PORTLAND HARBOR PROPOSAL PLAN COMMENTS

SILTRONIC CORPORATION

PREPARED FOR
SILTRONIC CORPORATION
SEPTEMBER 6, 2016
PROJECT NO. 8128.02.03

Figure 1
Riverbank Surface Soil Sample Locations
Siltronic Corporation
Portland, Oregon

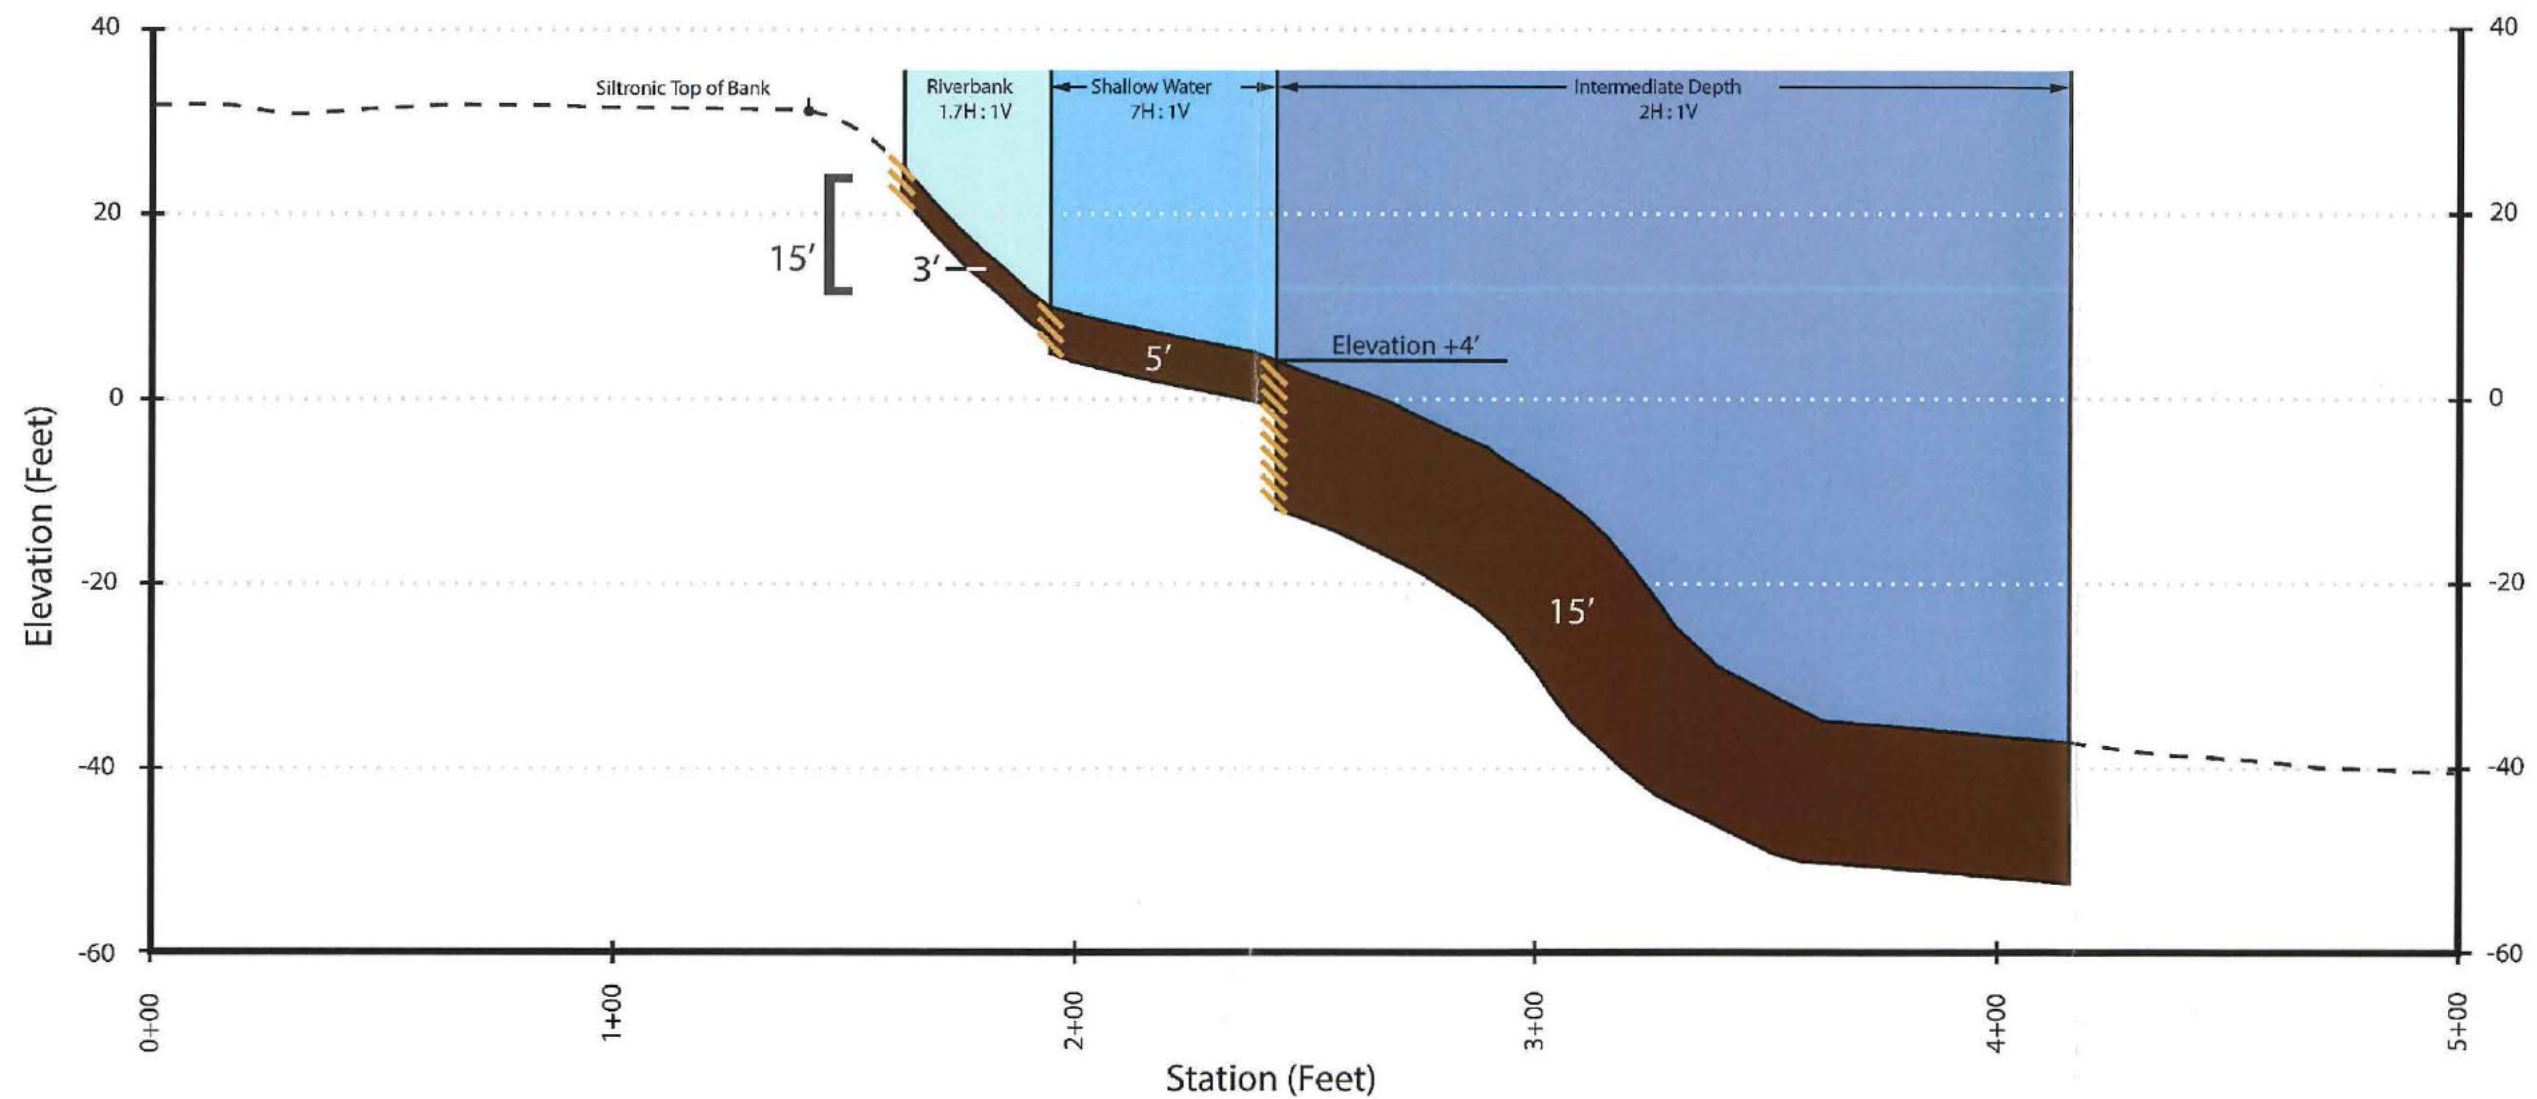
The Siltronic riverbank is not known to be contaminated. Riverbank areas presumed by EPA to be contaminated should be defined in the ROD as “potentially” contaminated and should be subject to further assessment if RAO 9 is included in the ROD.

The PP and FS do not provide the basis for the “known contaminated” designation. In the PP, it is indicated that “more information” is included in the FS Appendix A riverbank database³ (see PP page 13). The database includes a disclaimer indicating that “these data have not been checked for accuracy, or usability and are presented as is with no warranty expressed or implied regarding utility of the data...this data compilation is not designed for use as a primary regulatory tool in permitting or citing decisions.” It is unclear how a database that has not been evaluated for accuracy or usability can be relied on to designate the entire Siltronic riverbank, let alone over 30,000 lineal feet at the Site, as contaminated. The database is also missing critical information, such as location coordinates, and includes various data unrelated to riverbank soils (e.g., tissue and water samples). It appears that data from the vicinity of the northern Siltronic shoreline (i.e., near the Gasco area) were included in the database. These data were not collected from the riverbank (see below), nor were they collected for the purpose of developing or evaluating remedial alternatives. No data for the middle and southern shoreline portions were included.⁴ EPA does not indicate how or if the available data were screened to determine presence of contamination.⁵

To further evaluate the riverbank erosion pathway, the DEQ-recommended bank stability scoring matrix (Bank Assessment for Non-point Source Consequences of Sediment, developed by the U.S. Fish and Wildlife Service) was applied to the Siltronic riverbank. Maul Foster & Alongi, Inc., completed this assessment, which includes photographs and scoring matrices, in May 2016 (see the attachment). Multiple riverbank transects were evaluated, and all transects scored “very low” to “low”

Figure 4
SDU7W Sediment Management Area (RM 6.6-6.8)
Siltronic Corporation
Portland, Oregon

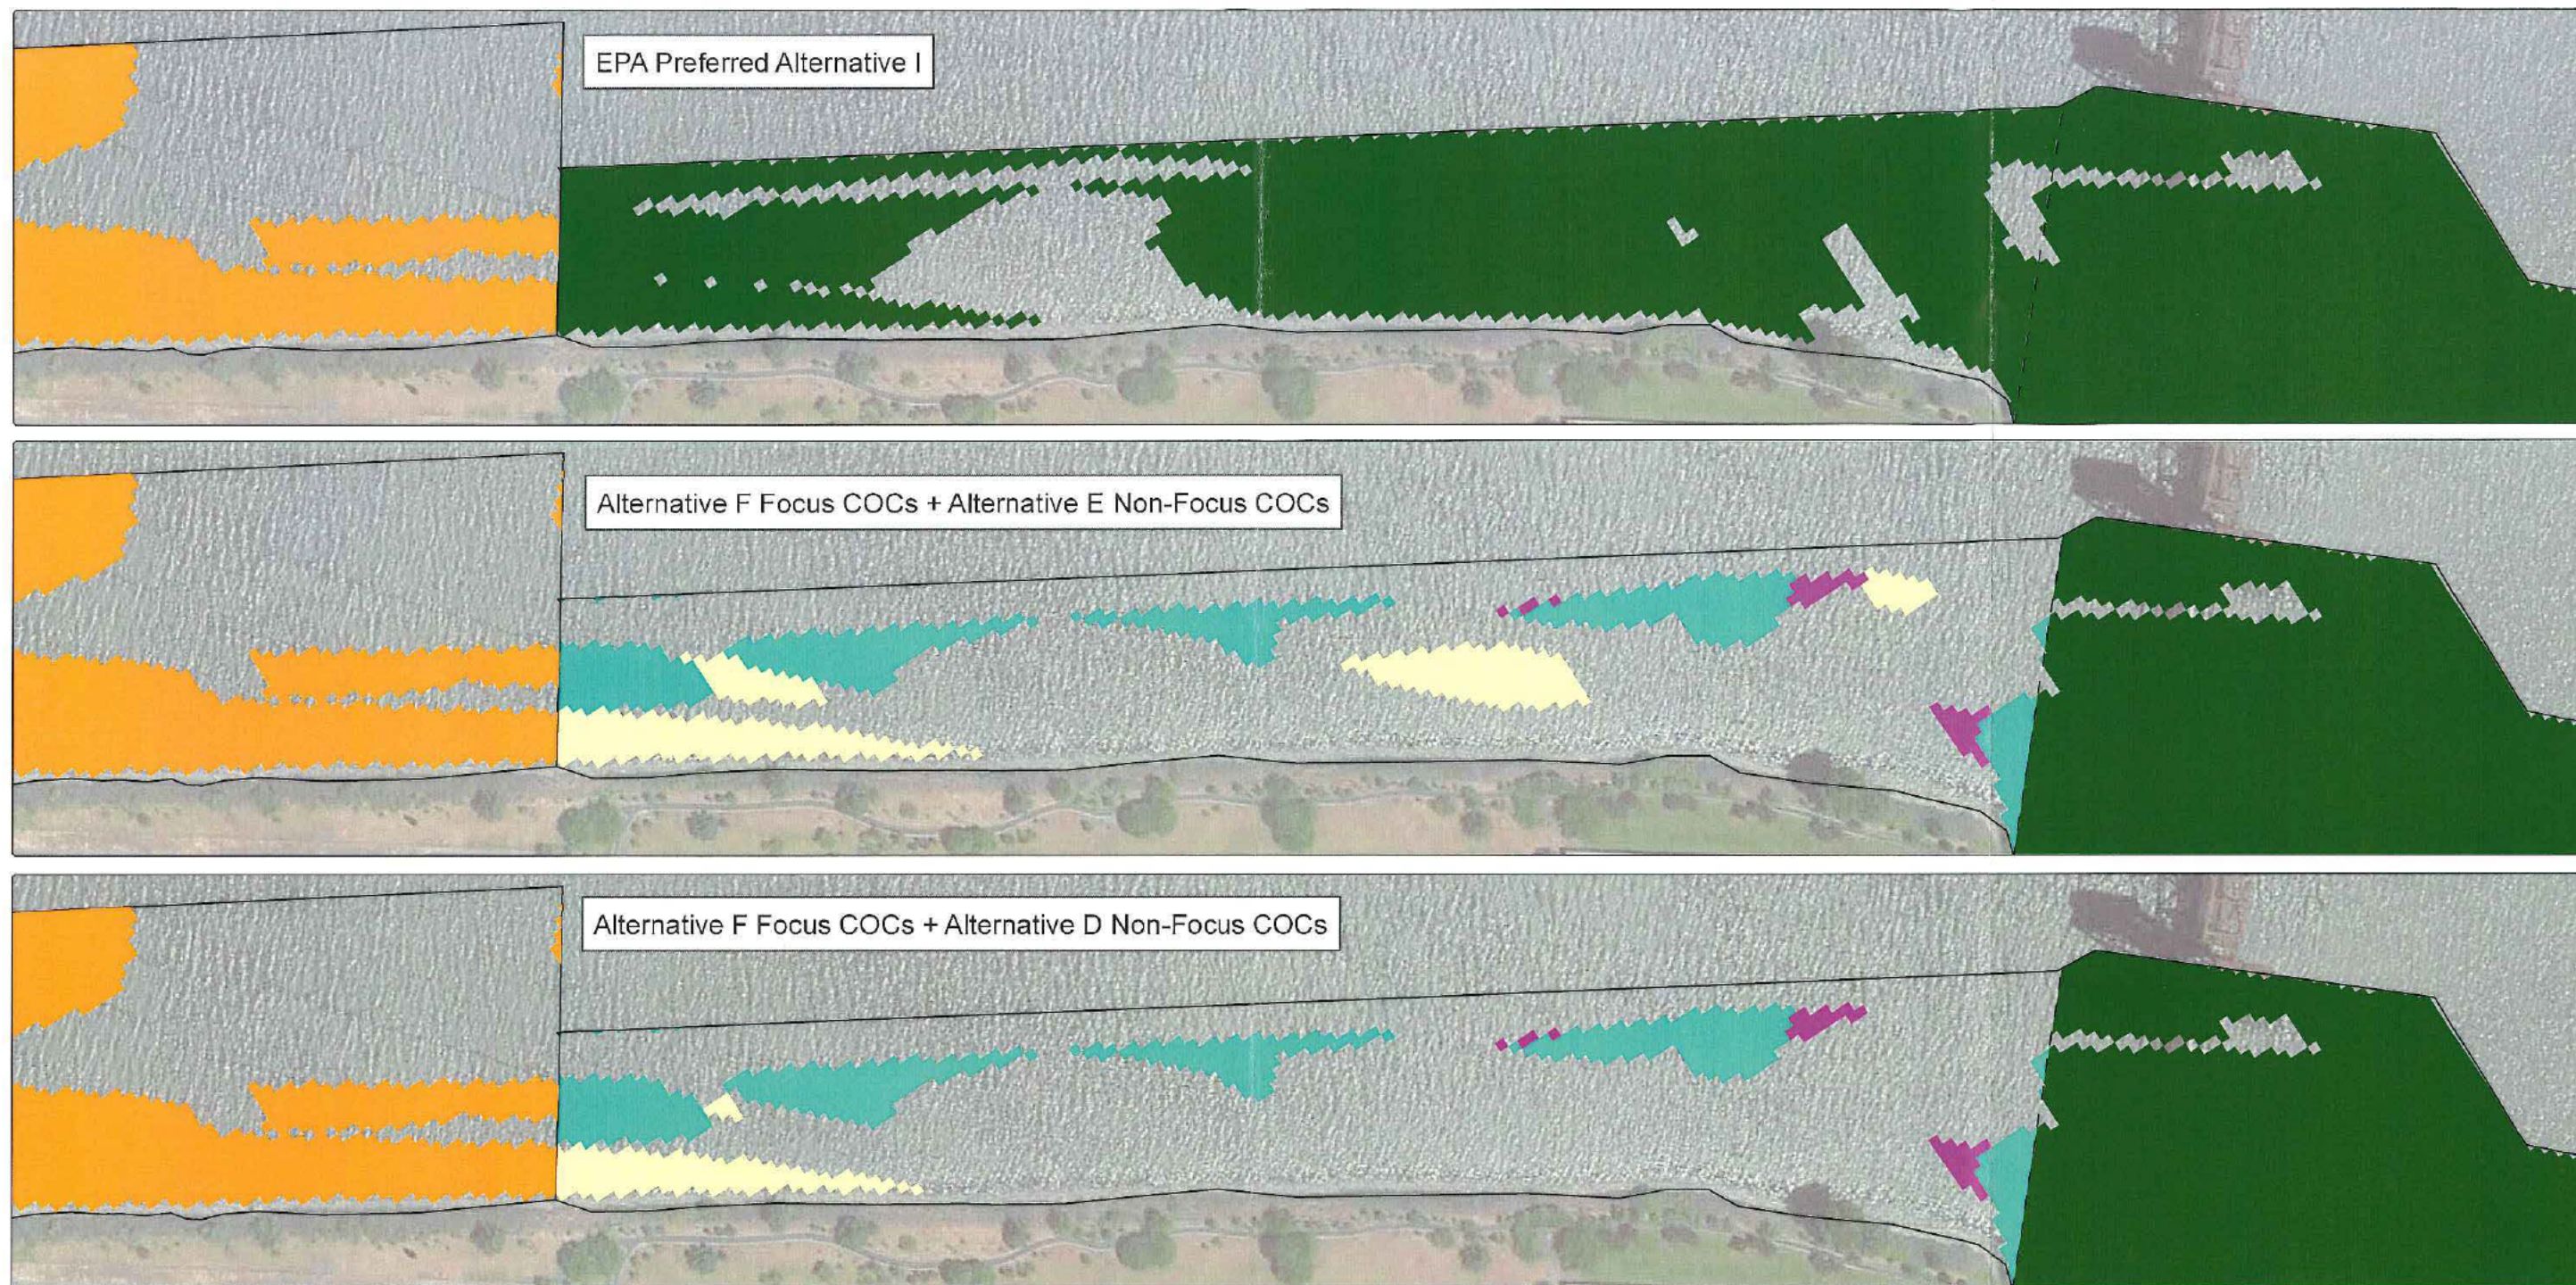
recreate the Alternative F SMA footprint, as shown in Figure 3, for purposes of further evaluation.⁸ As shown in Figure 4, only 1 acre is identified as SMA in this area based on focus COC Alternative F RAL exceedances; applying F RALs for non-focus COCs results in 4.21 acres of additional remedy area. That is, the non-focus COCs account for approximately 80 percent (4.21 acres) of the total SMA footprint (5.21 acres) near Siltronic. Using all Alternative F RALs results in the unwarranted designation of additional SMA area near Siltronic (RM 6.6-6.8W) that is based exclusively on non-focus COCs (primarily total polychlorinated biphenyls [PCBs] and polycyclic aromatic hydrocarbons [PAHs]).

A significantly smaller active remedy area is identified in the RM 6.6-6.8W area if Alternative D or E RALs⁹ are applied for non-focus COCs while Alternative F RALs are retained for the focus COCs (see Figure 4). Application of Alternative E RALs would identify 1.8 acres, and 1.4 acres would be identified if applying D RALs and the “highly toxic” principal threat waste (PTW) level for PCBs (200 parts per billion [ppb]).¹⁰ In these cases, the focus COCs account for approximately 60 to 70 percent of the SMA, while RALs consistent with other areas of the Site are applied for non-focus COCs.

Figure 5
SDU7W Sediment Management Area (RM 6.9-7.8)
Siltronic Corporation
Portland, Oregon

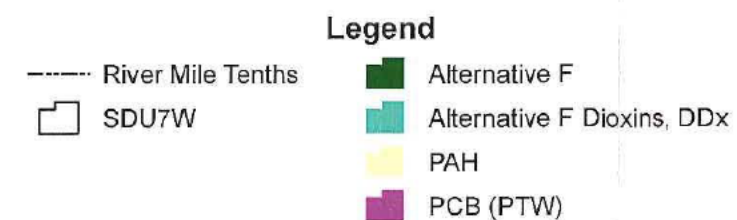
In contrast, use of Alternative D or E RALs for non-focus COCs minimally affects the SDU7W SMA portion offshore of Arkema (RM 6.9-7.5W) (see Figure 5). This is because elevated DDx and dioxins drive the SMA, as well as a small, substantially elevated PCB area that exceeds Alternative D, E, and F RALs. Upriver of RM 7.5W, DDx and dioxin concentrations significantly decrease and the approximately 4-acre SMA portion is mostly due to lower-level PCBs above the F RAL. Similar to the area offshore of Siltronic, this upriver area is relatively unaffected by the focus COCs, and just a 0.5-acre area would be identified as part of the SMA if more appropriate D or E RALs were applied for non-focus COCs (see Figure 5).

Figure 6
DNAPL Thickness
Measurements in
Wells Located on
Siltronic Property

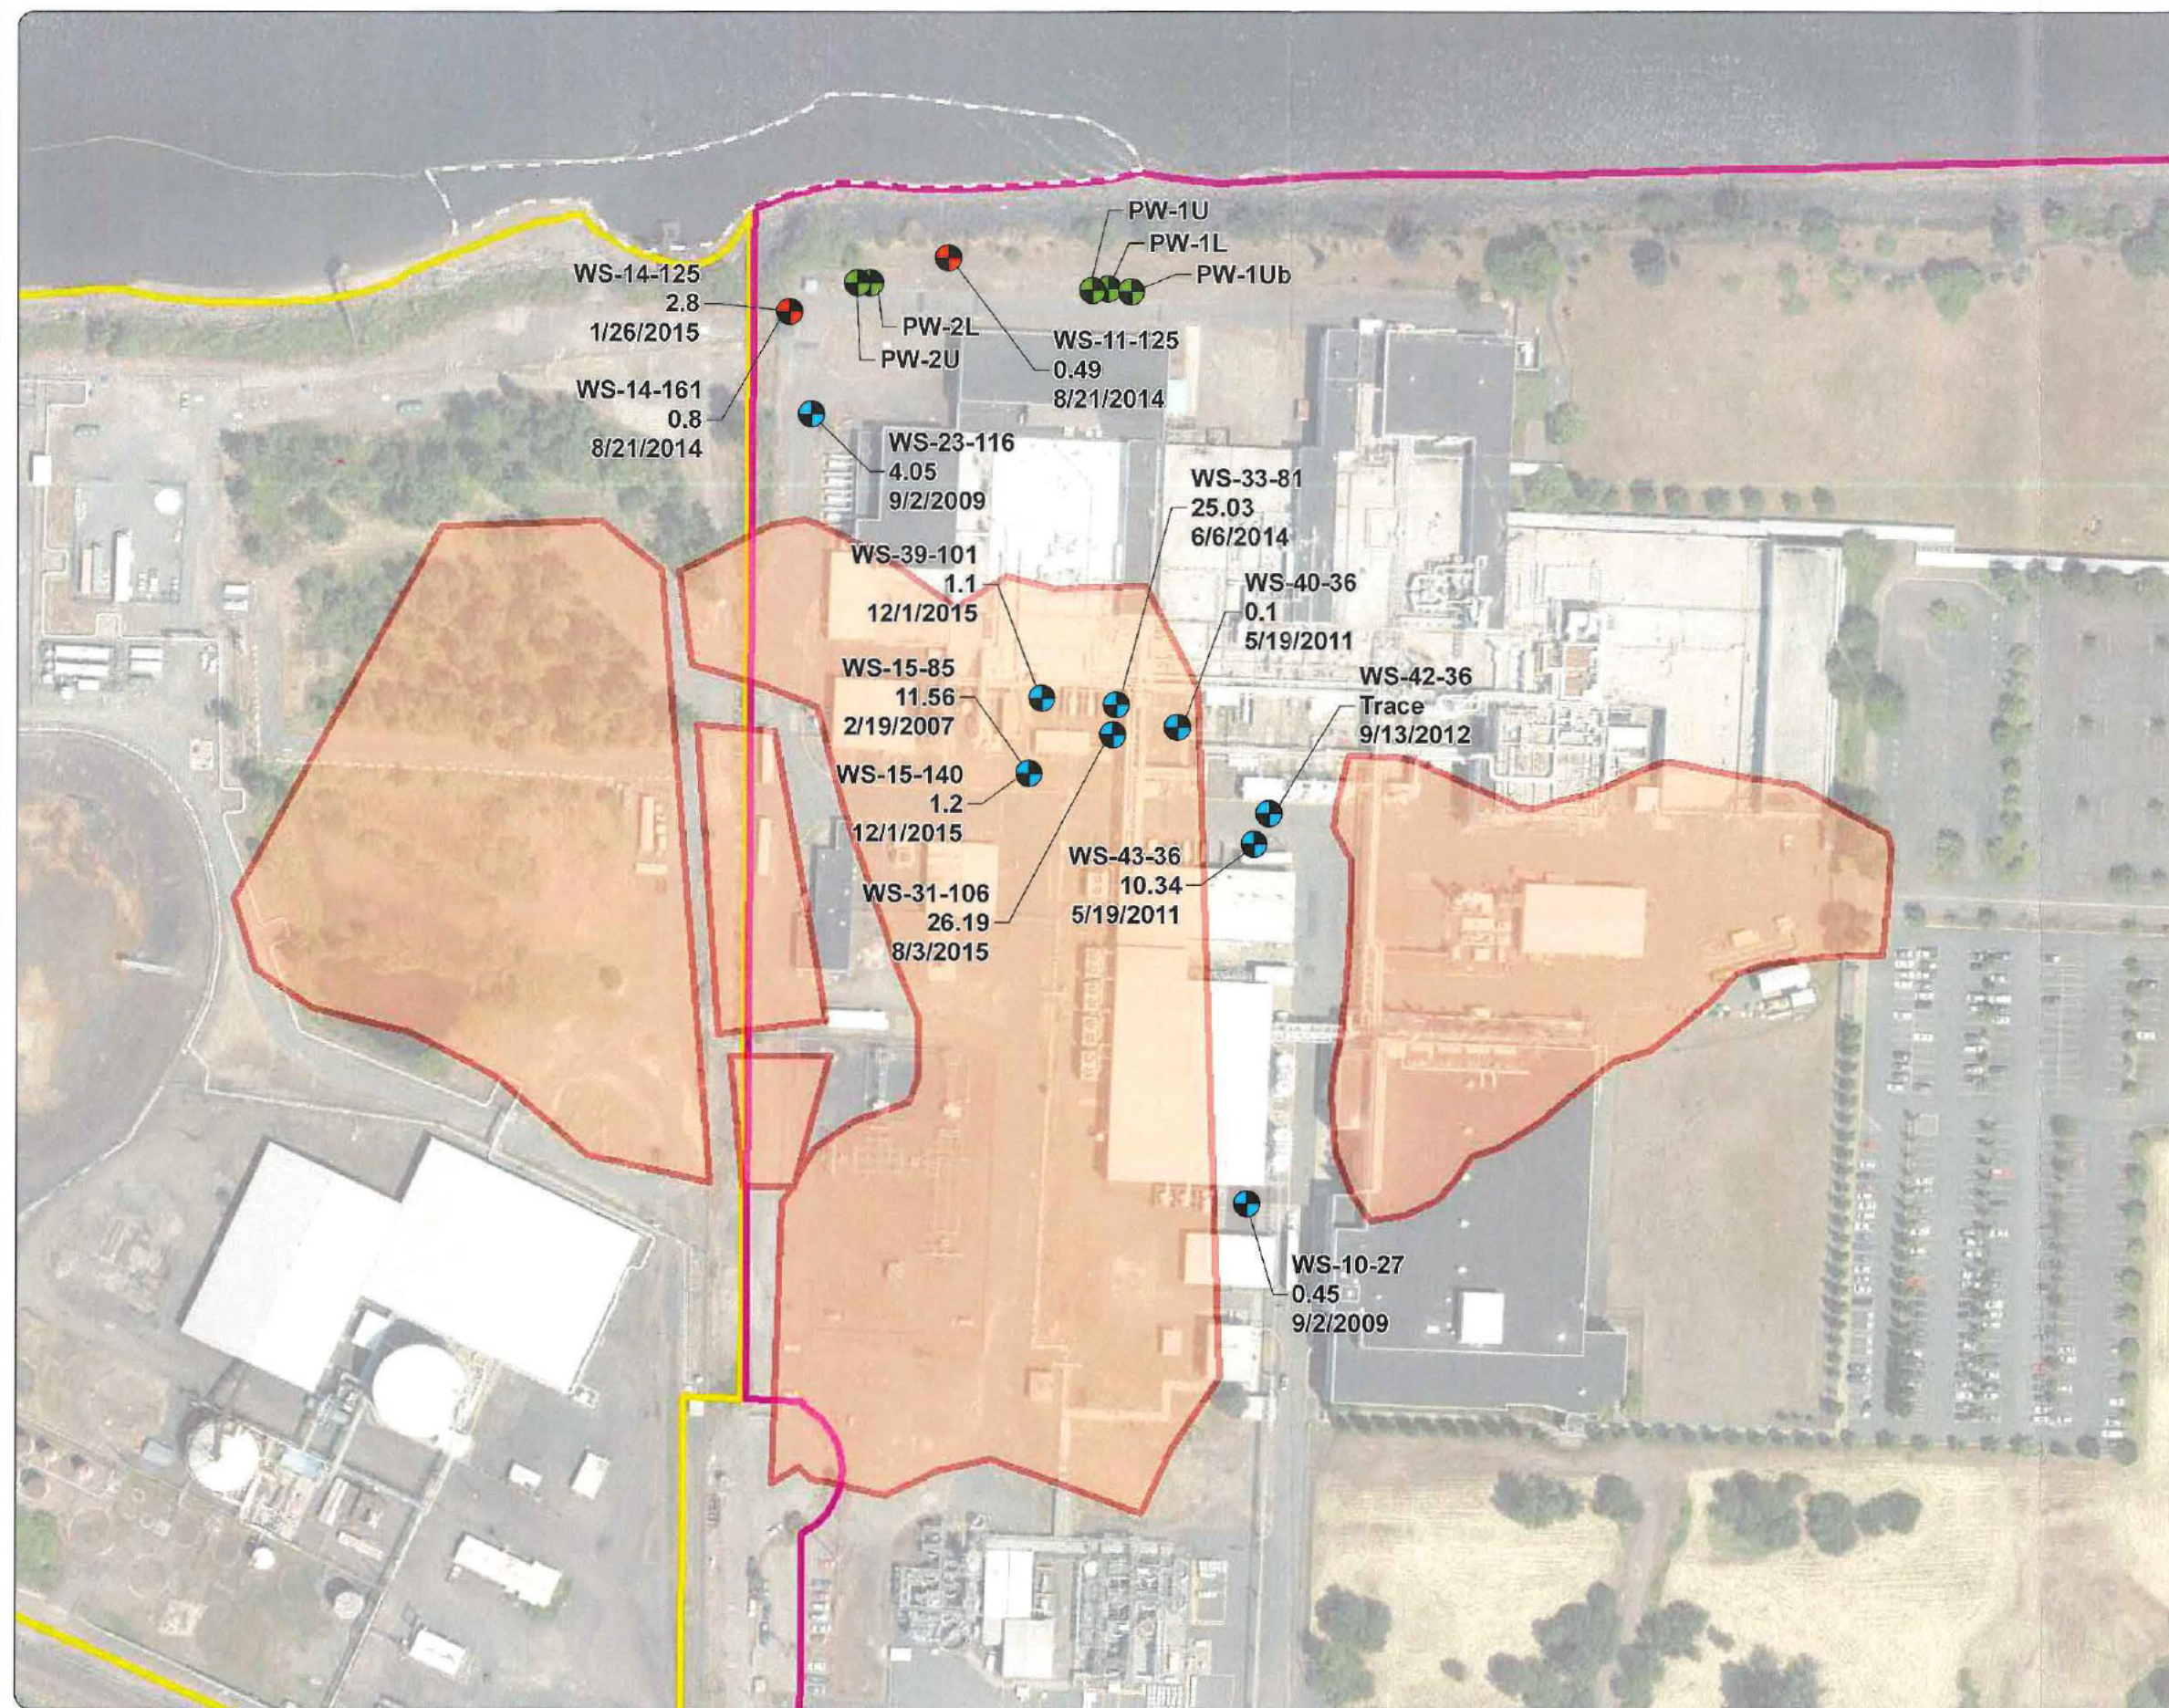
In the mid-1940s, NWN's predecessor, PG&C, developed a waste-disposal system, which included effluent ponds and a waste lagoon, on both sides of the current NWN/Siltronic property line (see Figure 6). Waste materials, including heavy and light oils, tars, emulsions, and other products from refining; gas manufacturing; and chemical production including solvents, pesticides, creosote, cyanides, and pitch, were disposed of. The estimates of the volume of wastes stored in these ponds range from approximately 6MM gallons to 32 MM gallons.^{16,17}

Today, light NAPL and dense NAPL (DNAPL) are present throughout the subsurface within and beyond the footprint of the former waste lagoon and effluent ponds. DNAPL has been observed entering wells screened as deep as 145 feet below ground surface.¹⁸ Figure 6 indicates the DNAPL thickness measured in various wells on the Siltronic property. The thickness levels fluctuate significantly over time, showing the dynamic state of the DNAPL (see Figure 7). NAPL is also present in the sediment offshore at depths of up to 16 feet below the mudline.¹⁹ NAPL continues to discharge to the Willamette River, and ebullition of NAPL to the surface water column is ongoing.
